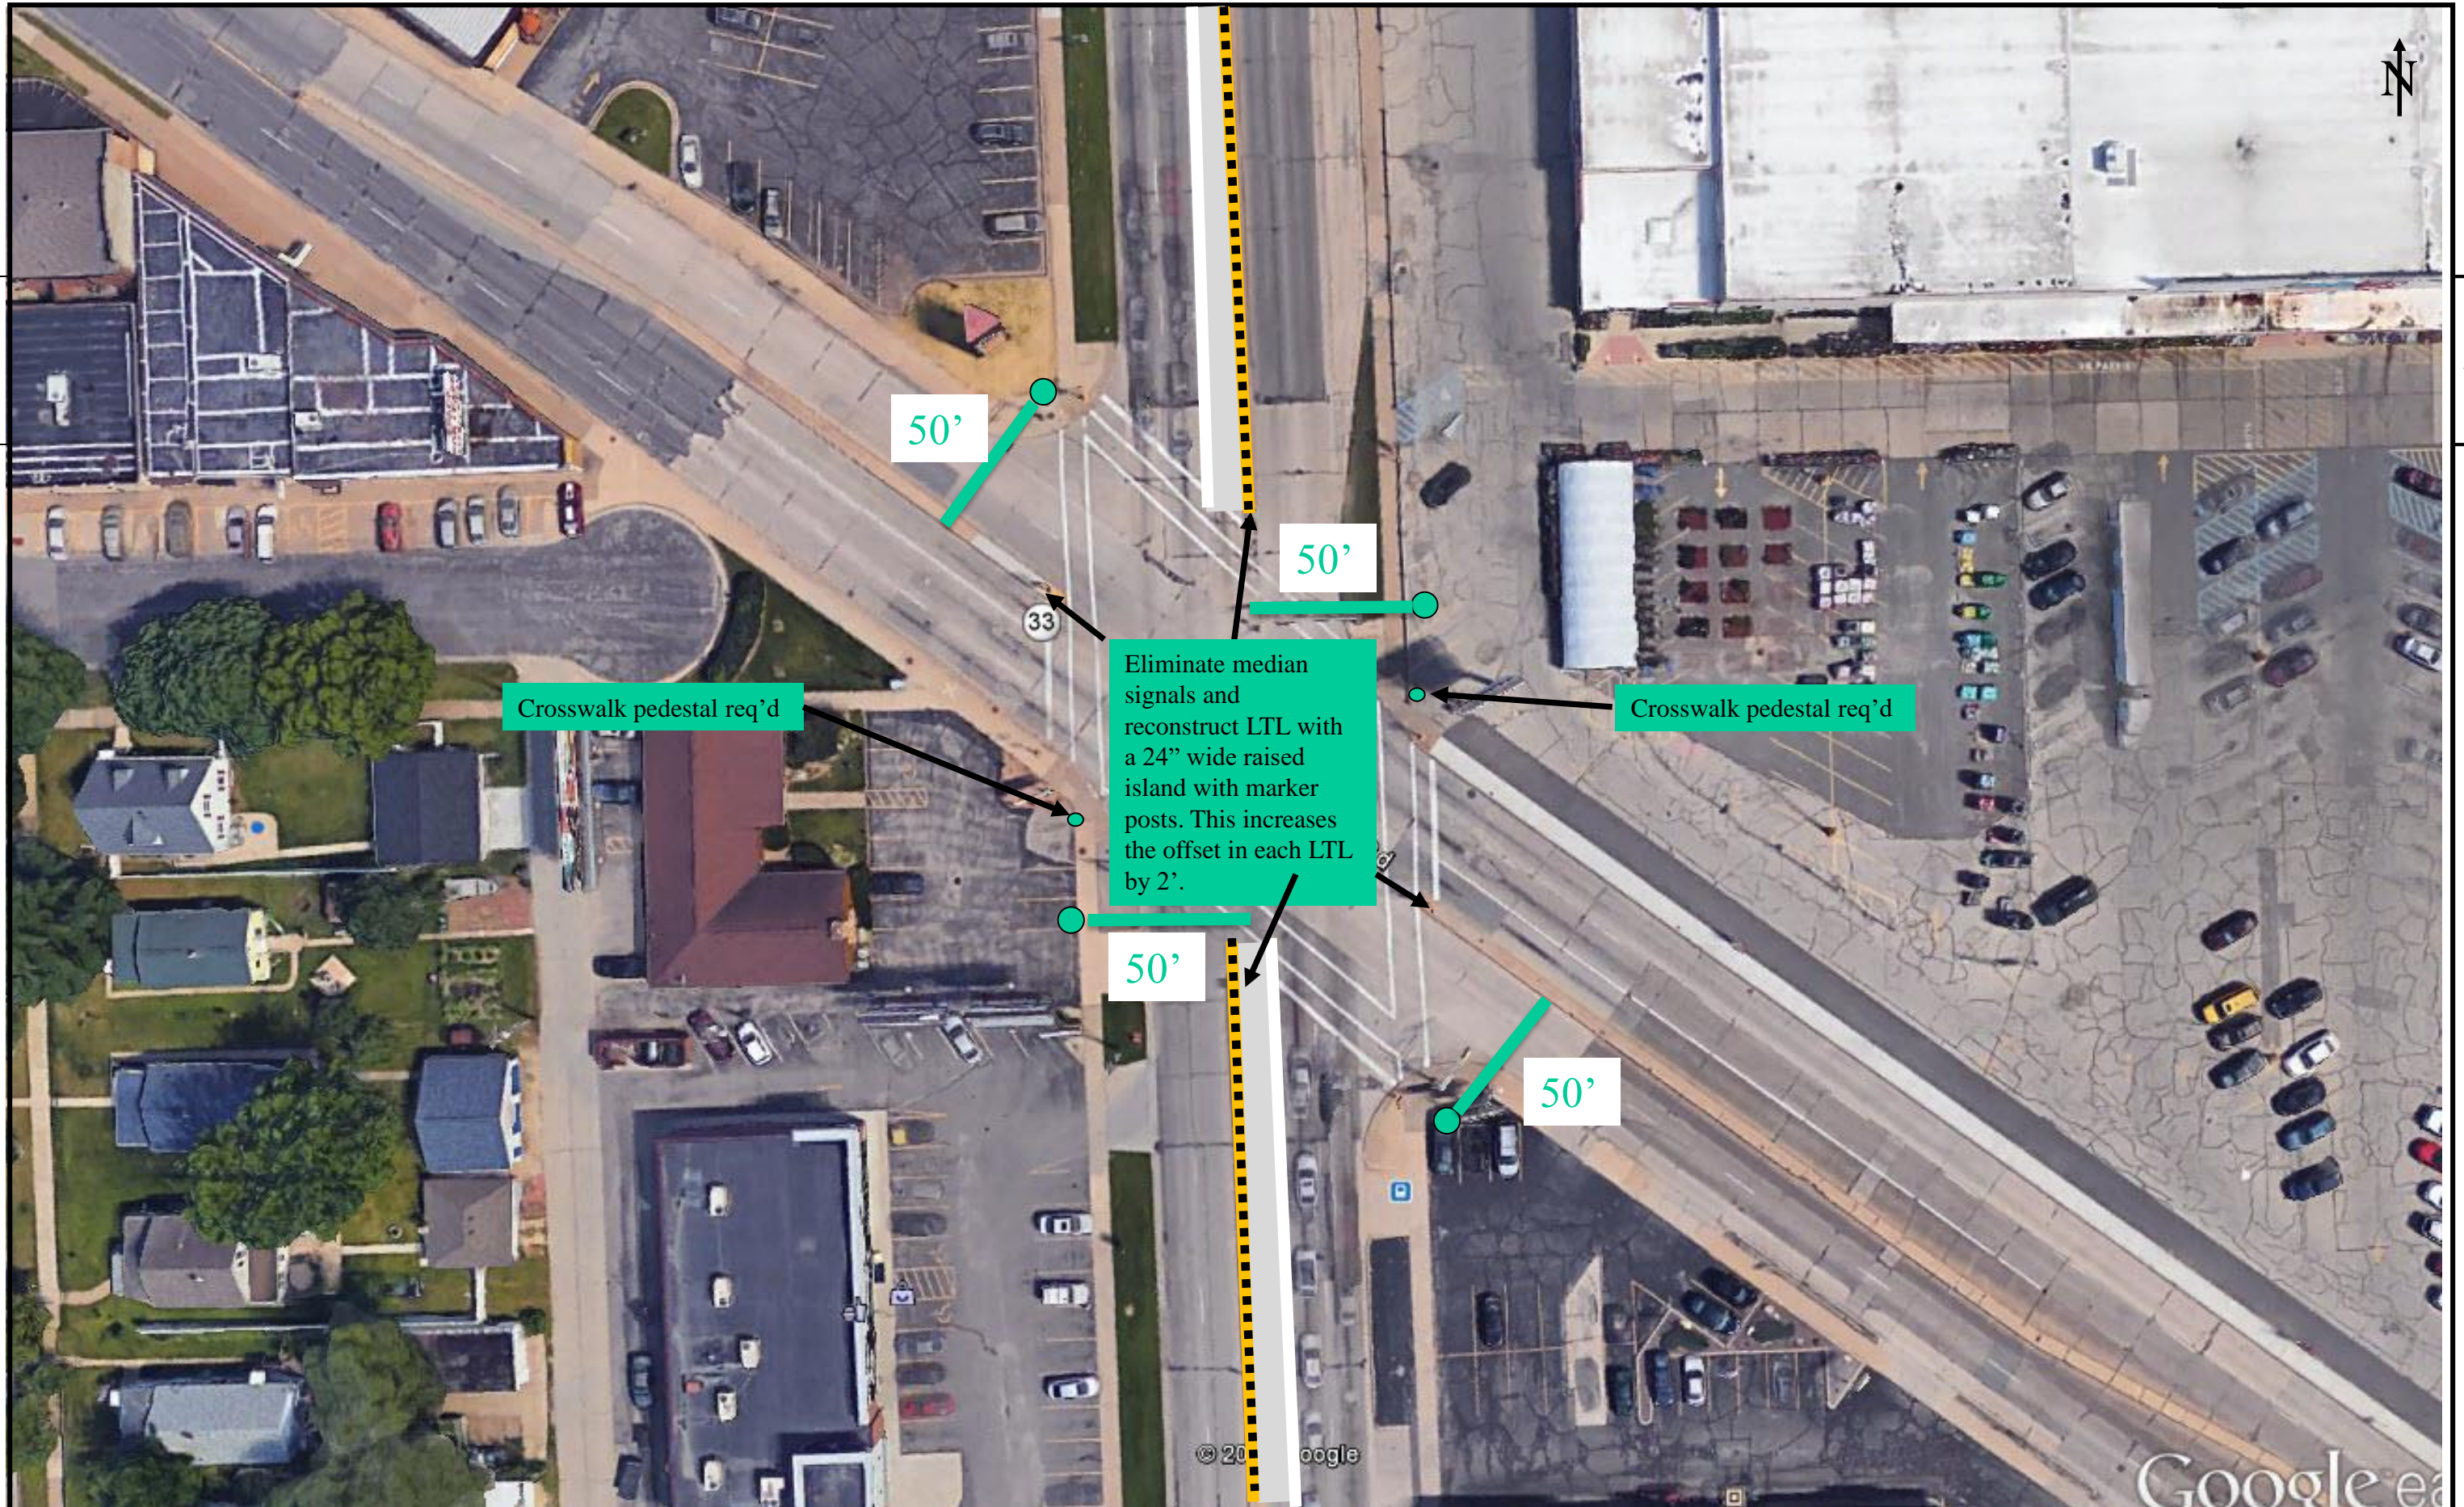
Eliminate median signals and reconstruct LTL with a 24" wide raised island with marker posts. This increases the offset in each LTL by 2'.

Crosswalk pedestal req'd

Crosswalk pedestal req'd

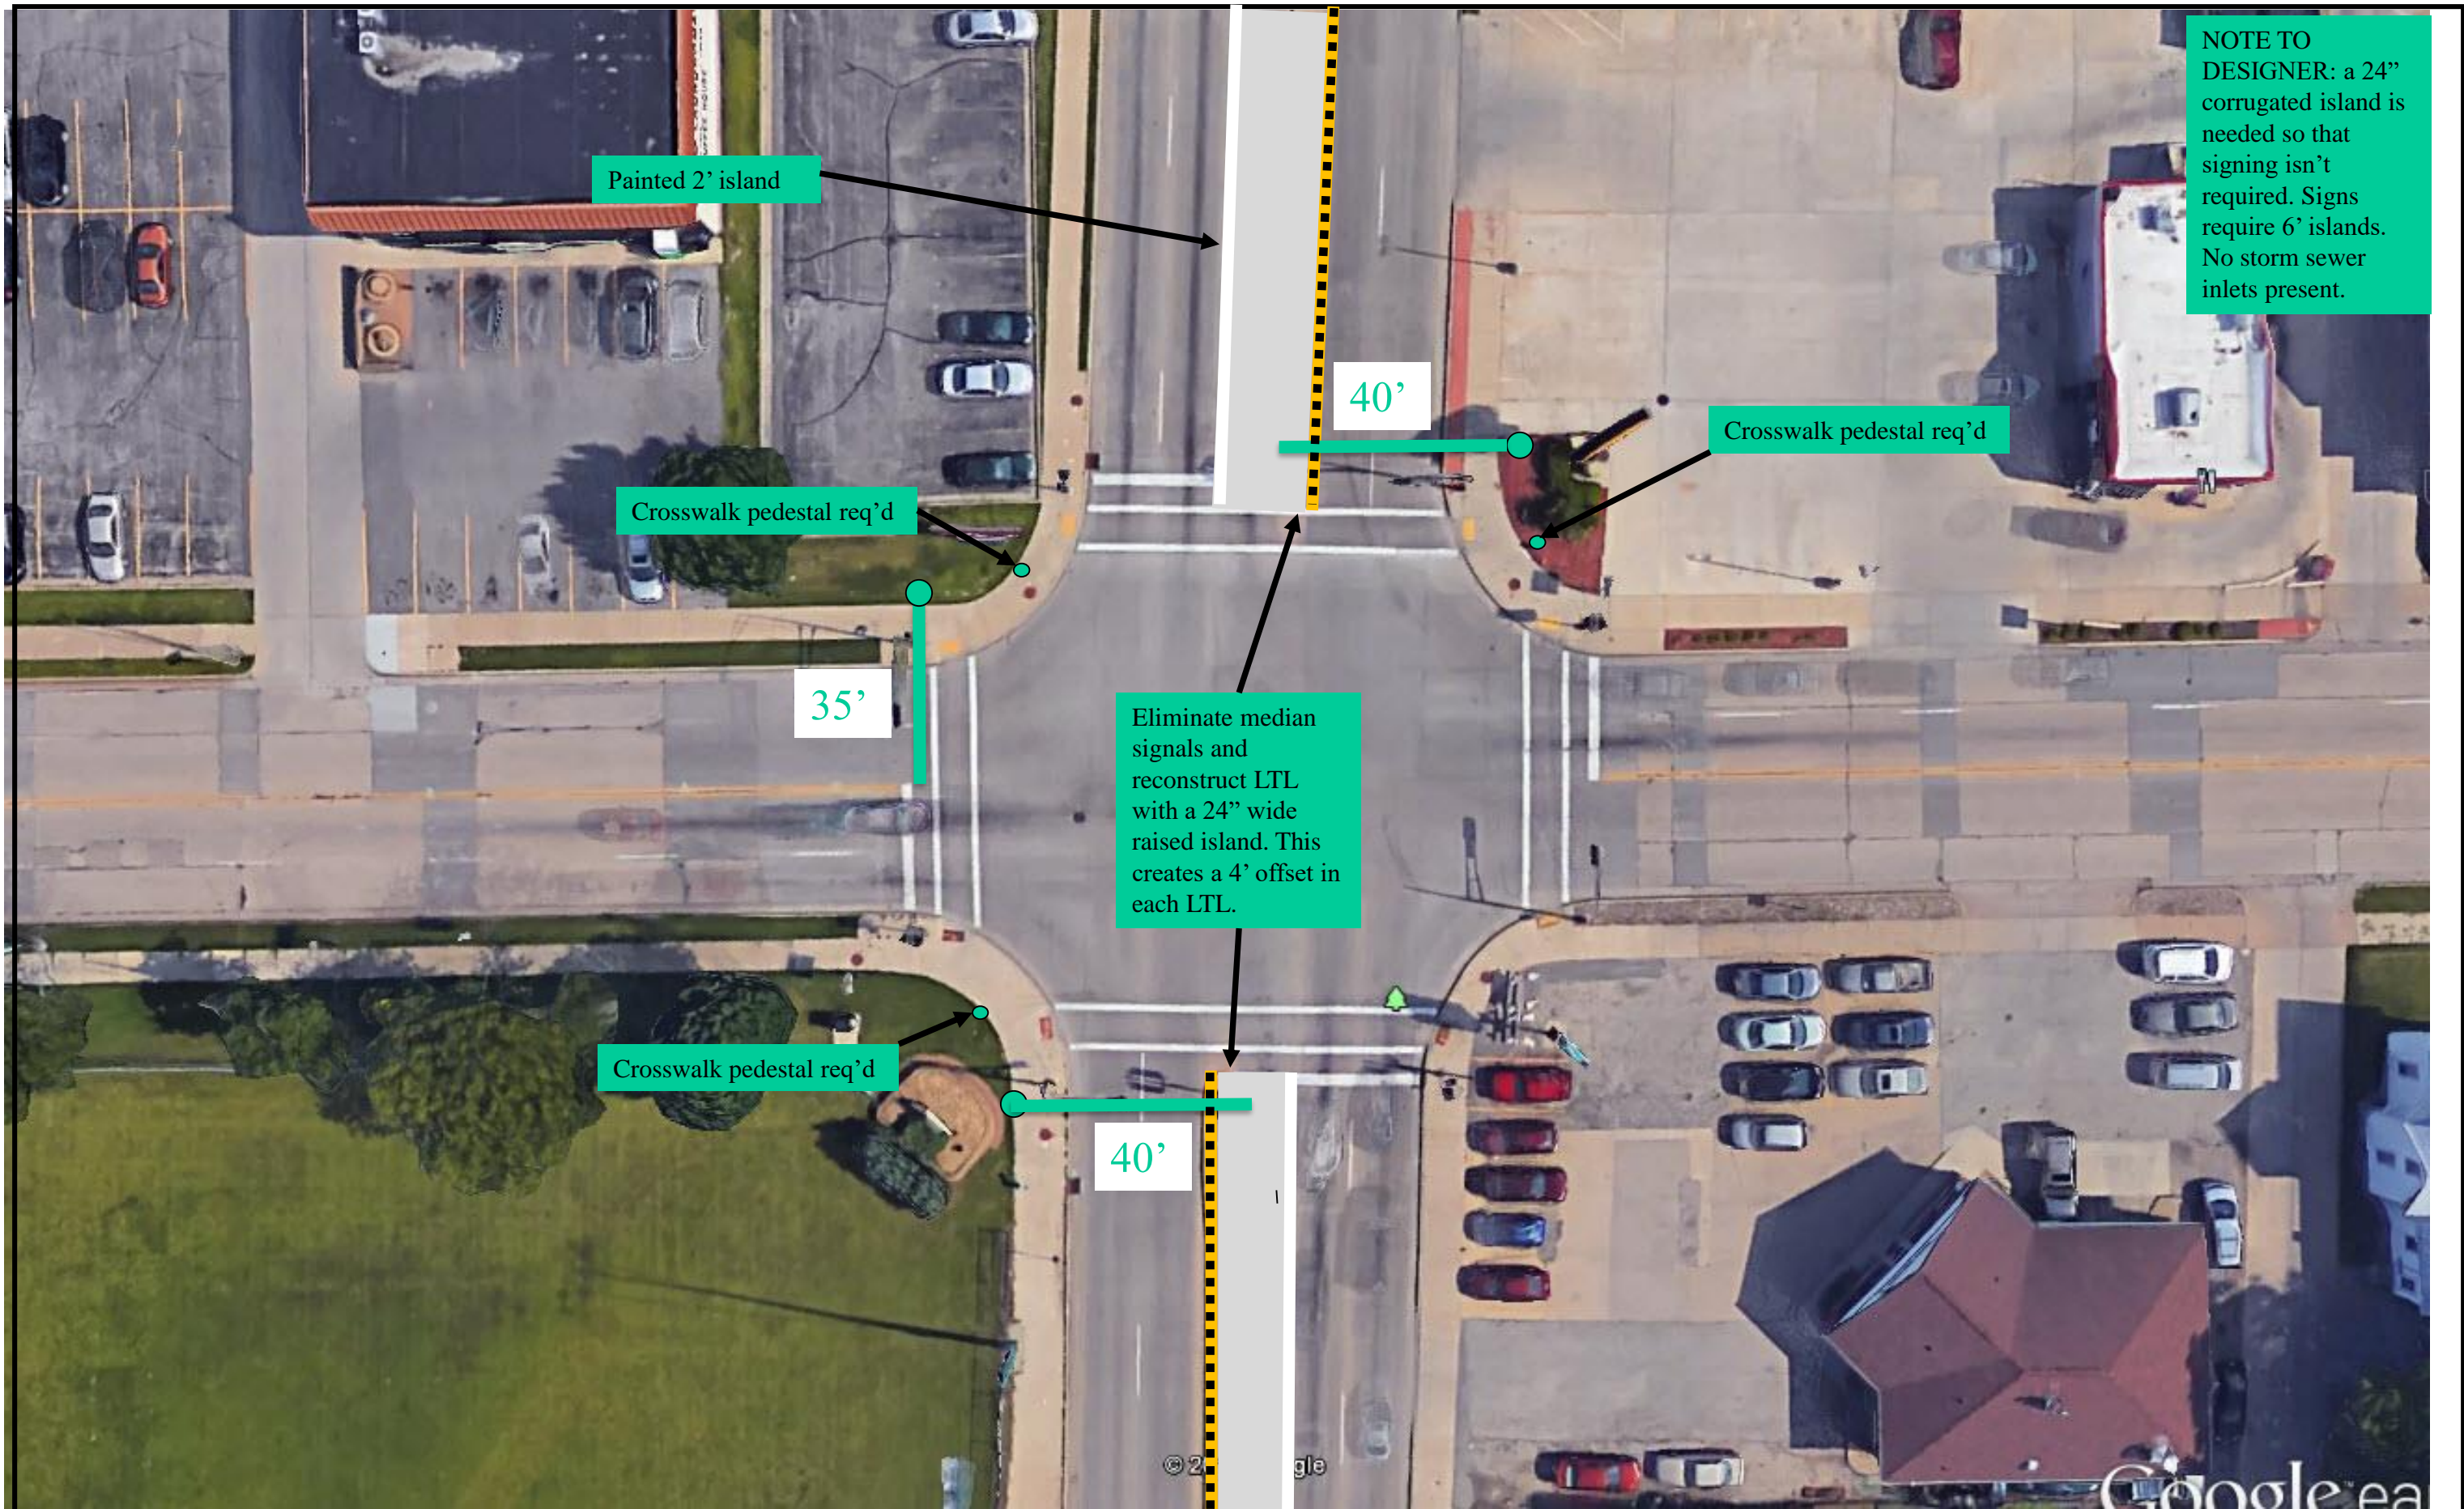
NOTE TO DESIGNER: a 24" corrugated island is needed so that signing isn't required. Signs require 6' islands. No storm sewer inlets present.

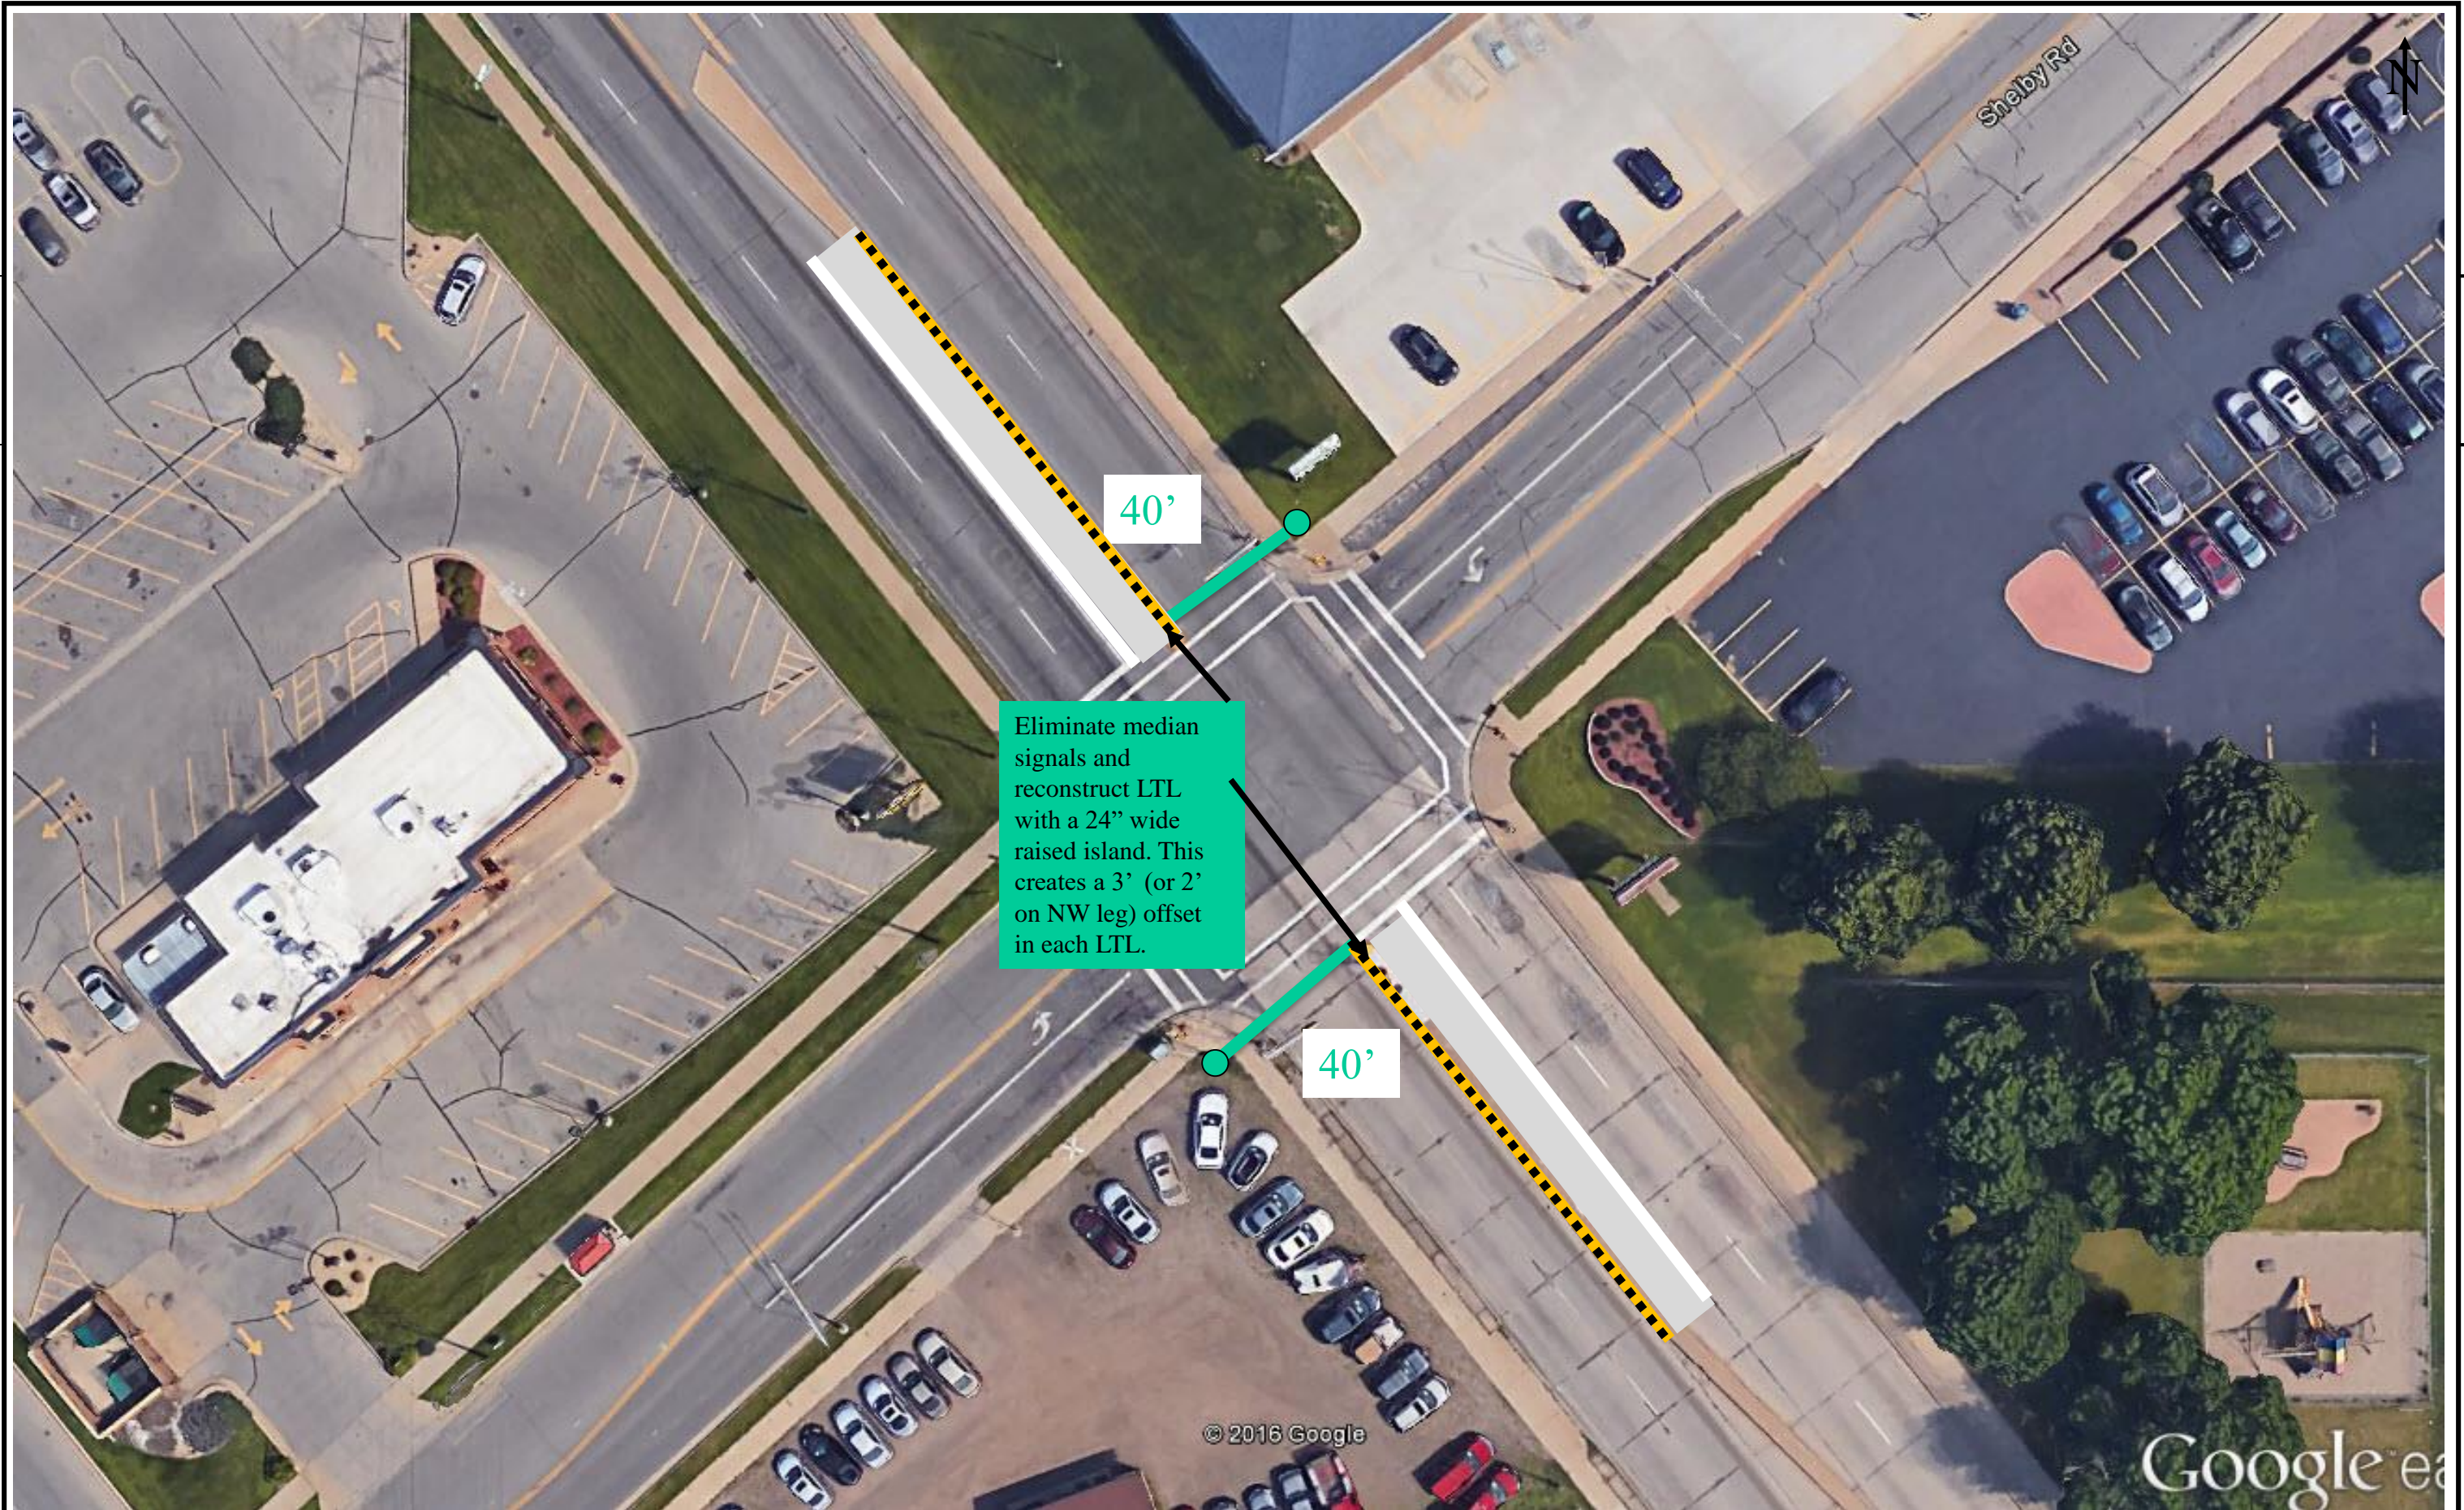
Eliminate median signals and reconstruct LTL with a 24" wide raised island. This creates a 3' (or 2' on NW leg) offset in each LTL.
